Section 16 Planning Application for Proposed Minor Relaxation of Gross Floor Area and Building Height Restrictions for Permitted Office Use and Other Permitted Uses in "Commercial (7)" Zone bounded by King's Road and Taikoo Shing Road, Quarry Bay (Application No. A/H21/160)

Revised Figure 2.2 of the Planning Statement
(rectification of a typo)

**Responses-to-Comments Table and
Revised Sewerage Impact Assessment**

SEWERAGE IMPACT ASSESSMENT

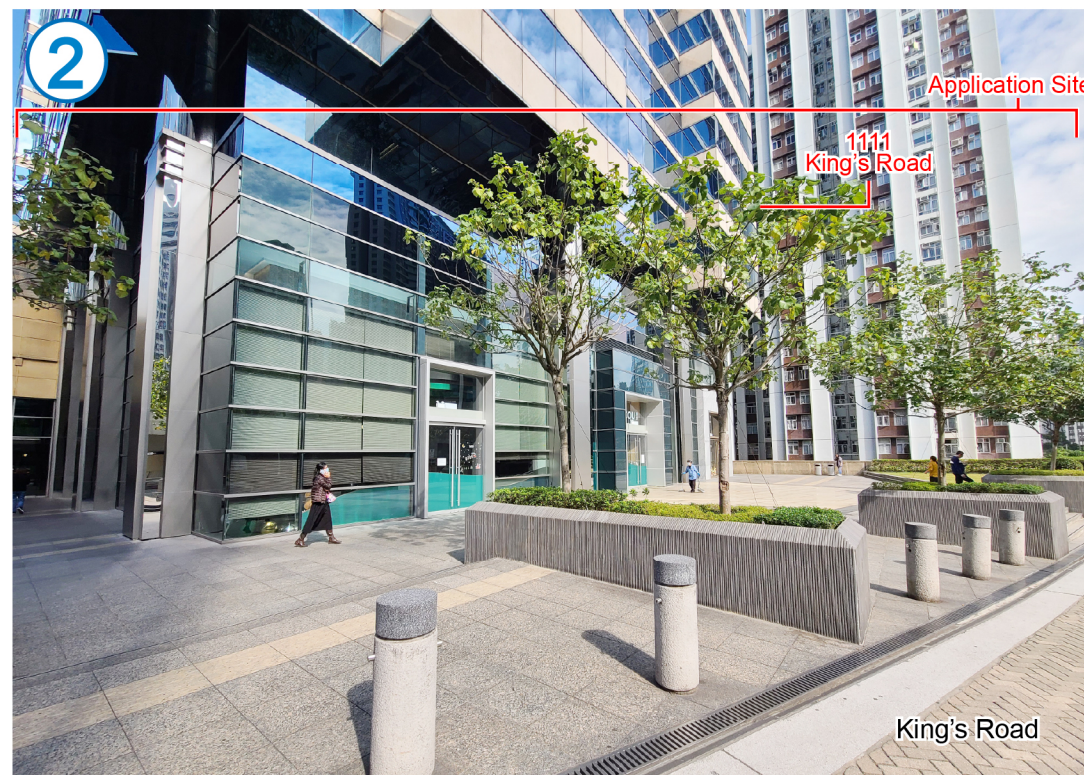
A typo was noted regarding the annotation of Kornhill Road Flyover in Figure 2.2 of the PS. Attached please find the revised Figure 2.2 with the typo rectified for reference.

Title: Existing Sewerage System in the Vicinity of the Subject Site

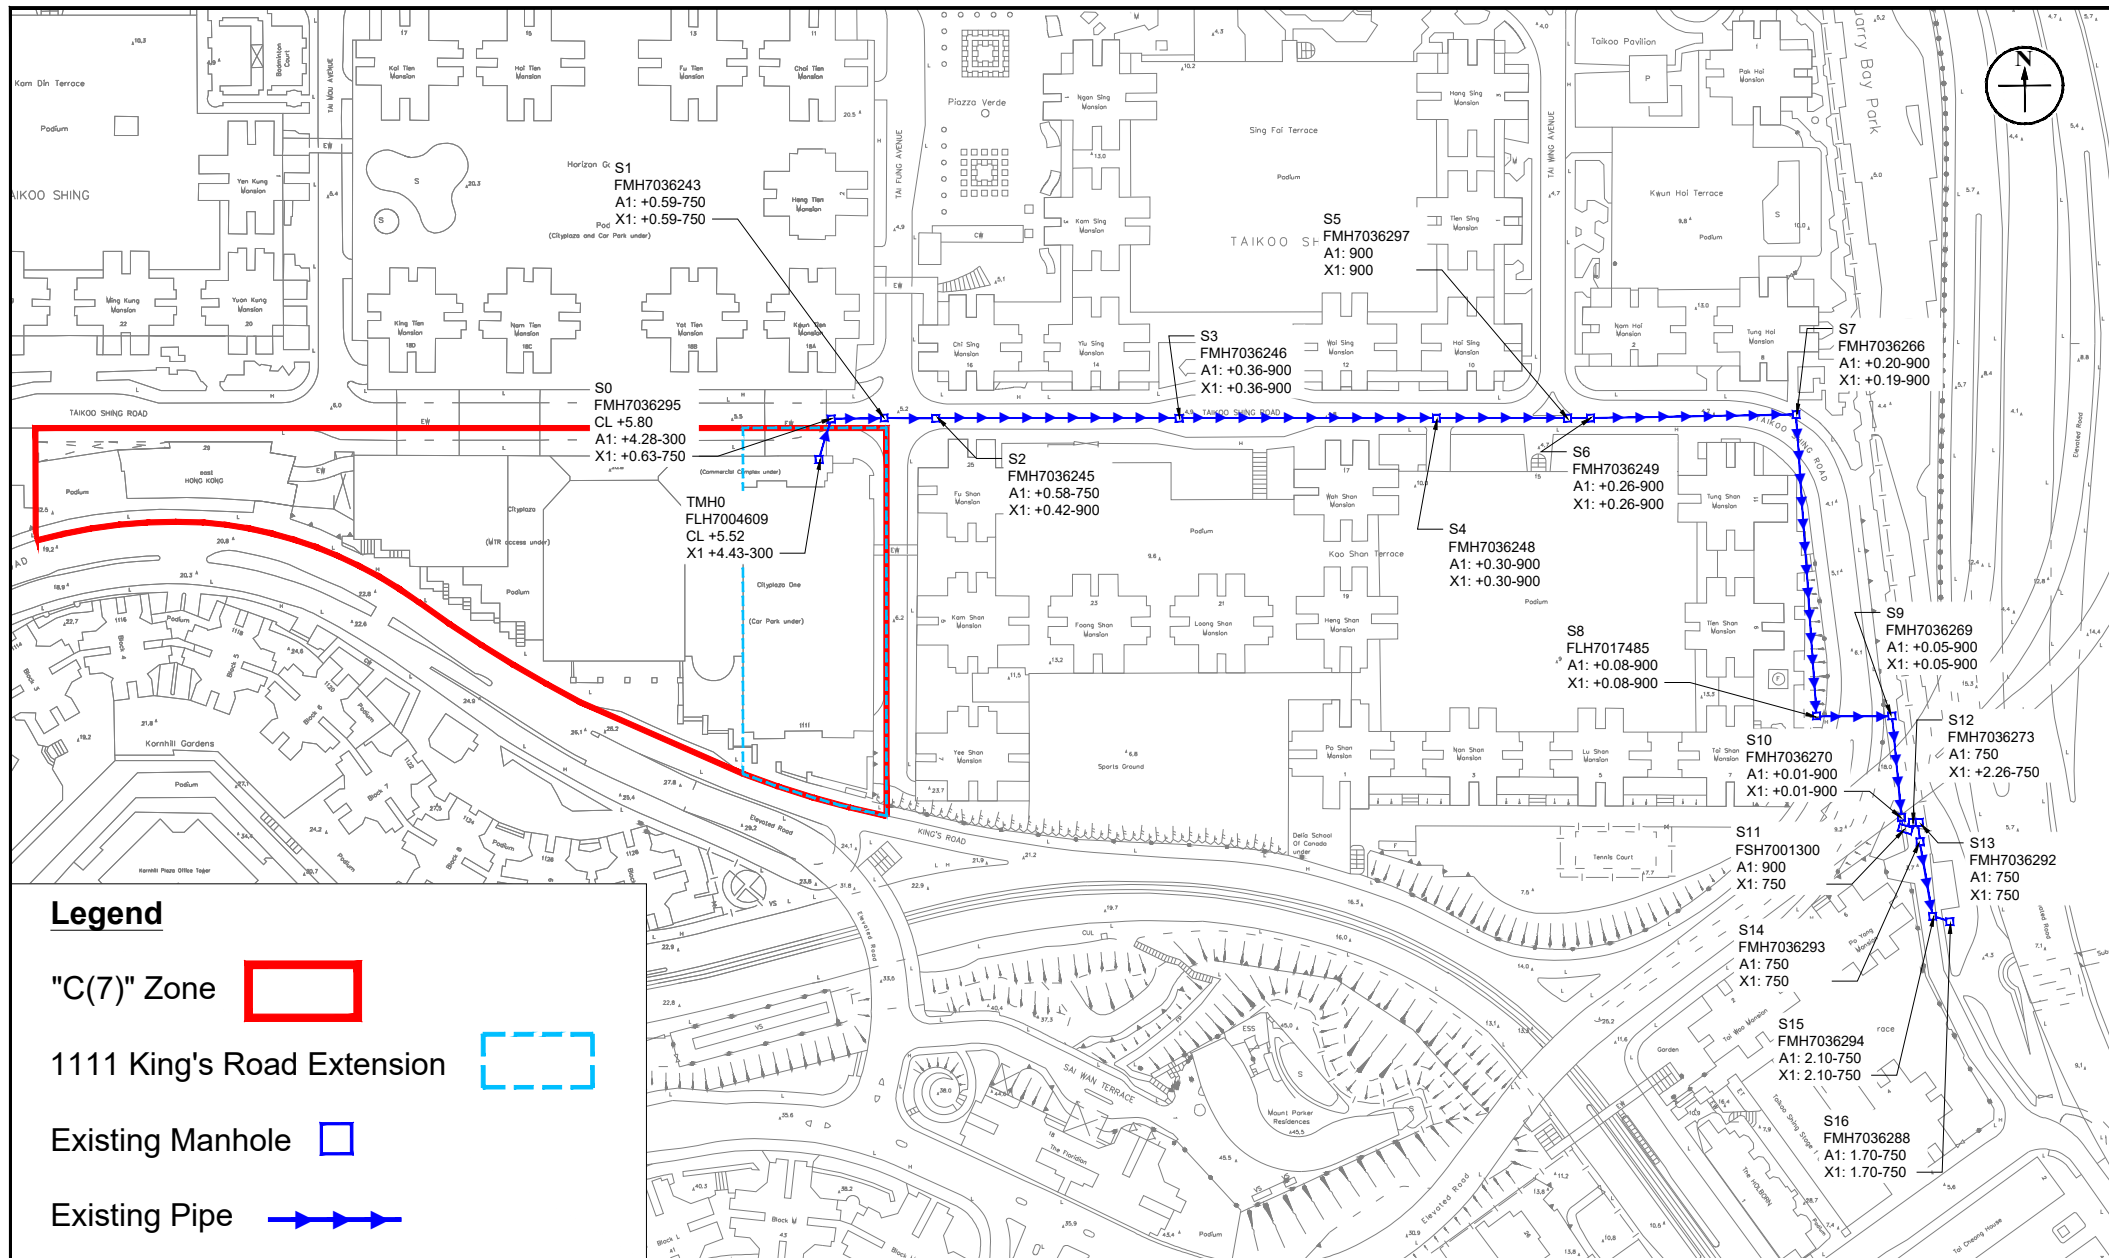
Departmental Comments	Responses to Comments
2.	Comments from Environmental Protection Department	
2.1	For Sections 2.3.1 and 2.5.1, according to Figure 2.1, sewage generated from the Proposed Development will be directed to manhole FMH7036295 rather than to FMH7036243, please revise.	Revised accordingly, please refer to the revised SIA.

Title: Proposed Upgrading Sewerage System

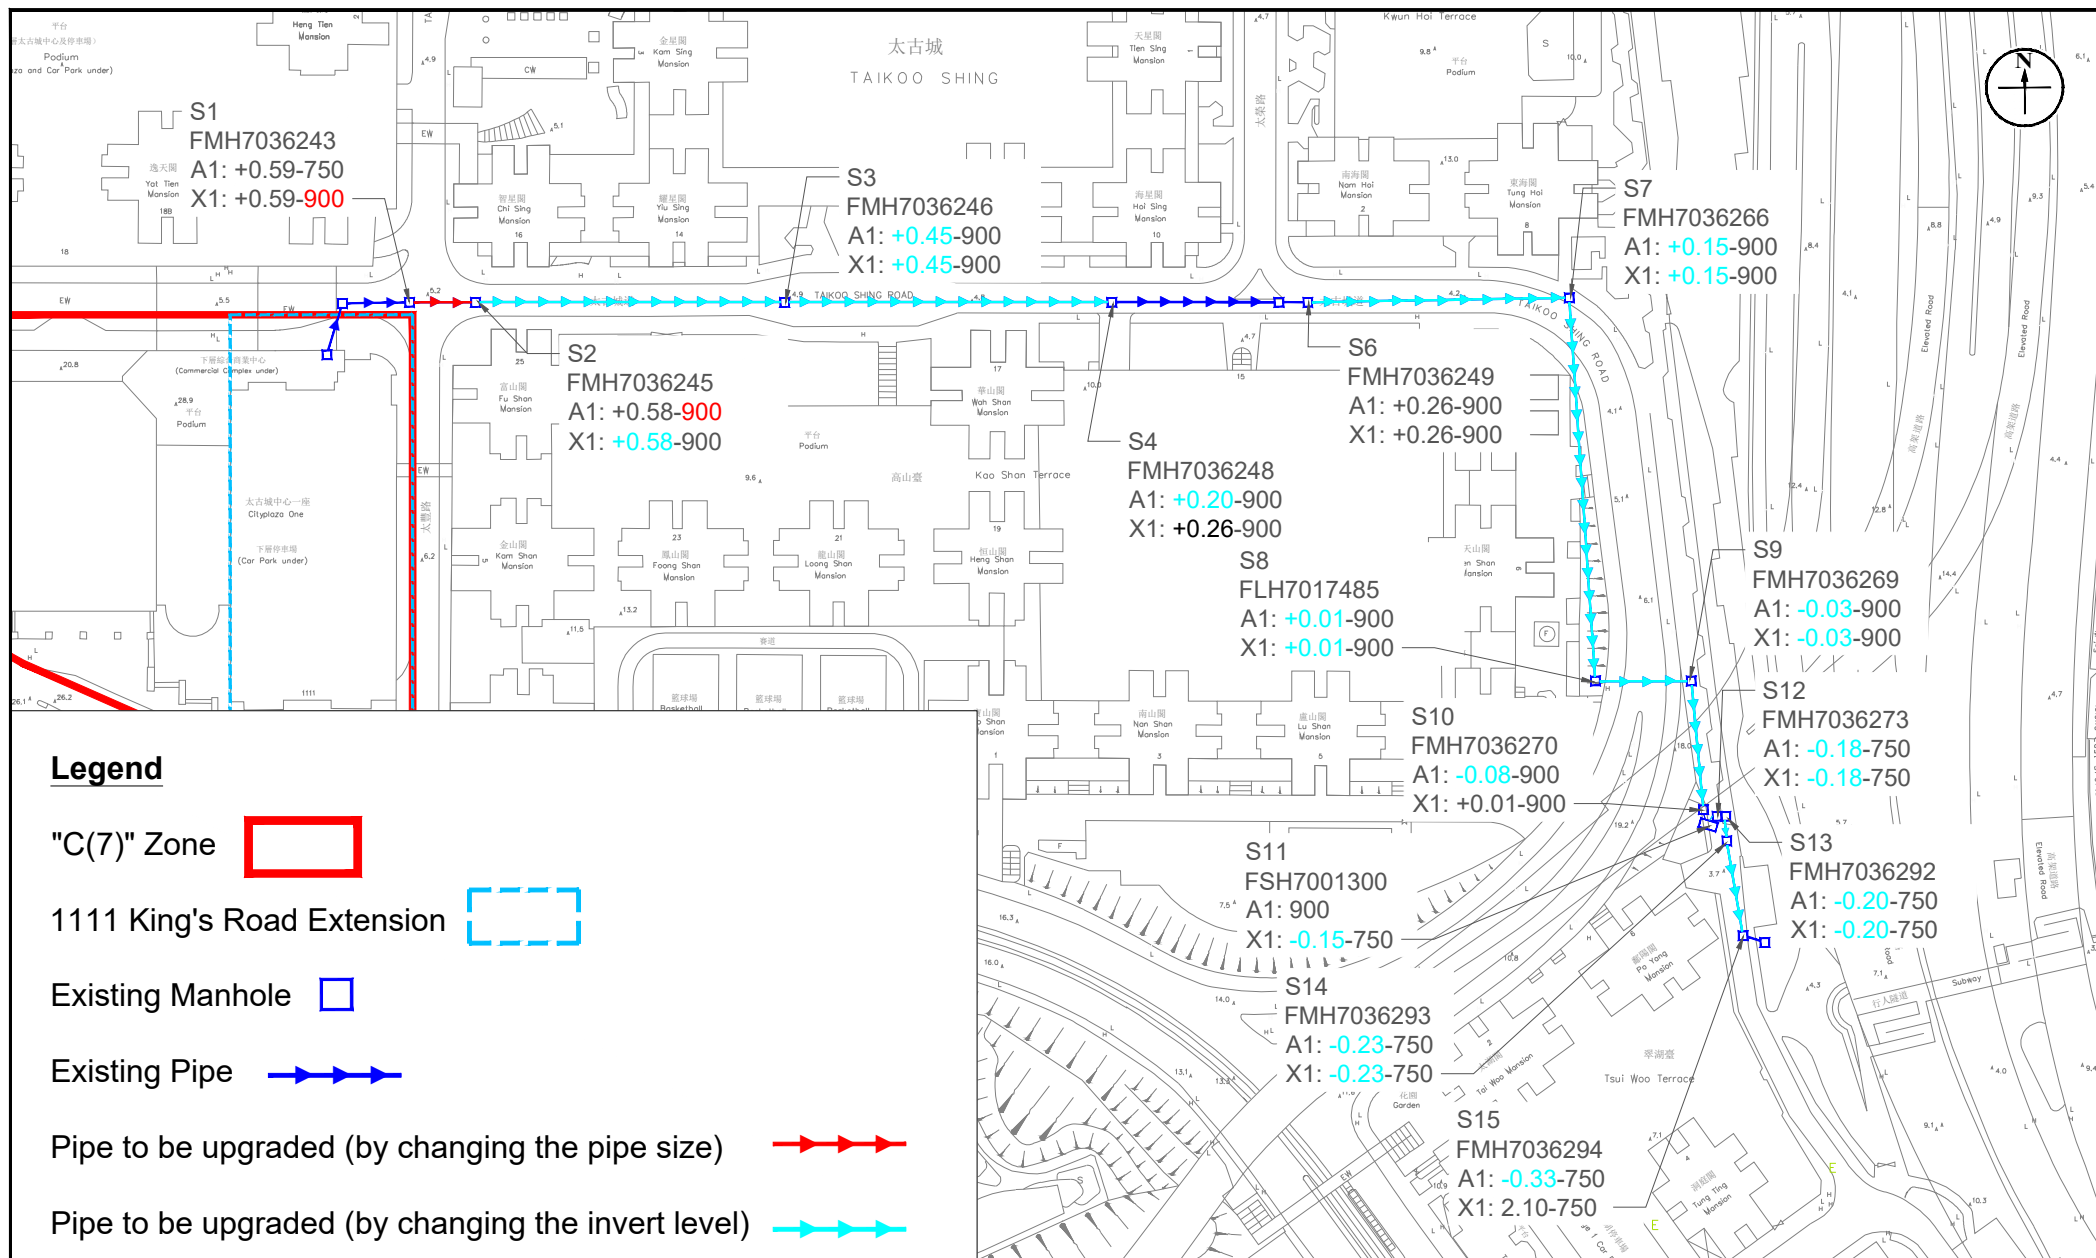
1.9	Figure 2.3 - Both the proposed upstream invert level and downstream invert level for pipe segment S6-S7 are +0.15 mPD resulting zero pipe gradient. Please review.	Typo for the downstream invert level of manhole S6. It should be "+0.26" instead of "+0.15". Please refer to the revised SIA.
